Audio-Technica Corporation
FCC ID : JFZATH-CKR75BT
IC: 1752B-CKR75BT
Part 15C Certification

Class II Permissive Change

A circuit difference between ATH-CKR75BT and AT-WLA1

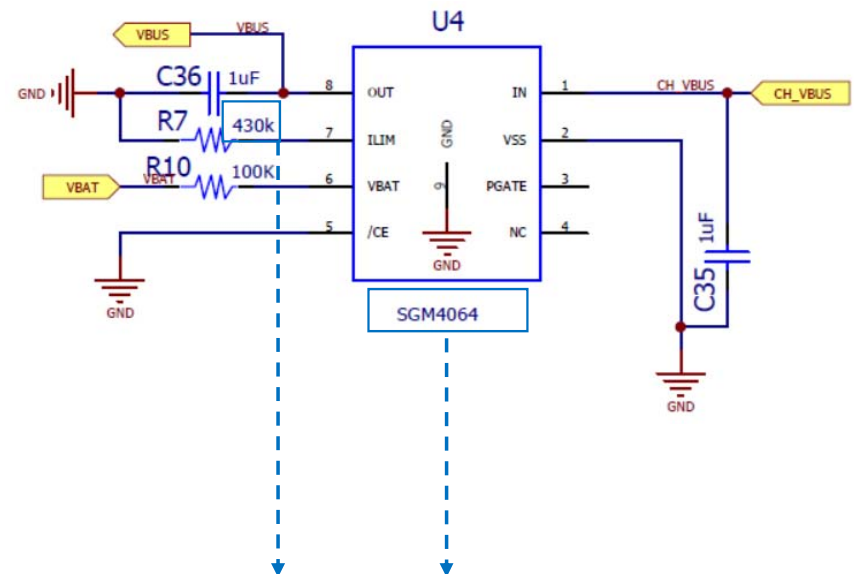
Parts of the U4(Protection IC) and R7(Protection Current Value determination Resistance) are different.

The Mechanism difference between ATH-CKR75BT and AT-WLA1

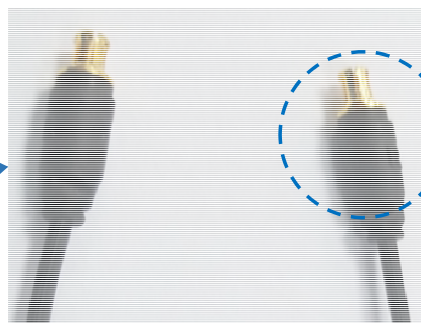
ATH-WLA1 Earphone Section Picture(Earphone Not included)

ATH-CKR75BT Earphone Section Picture(Earphone included)
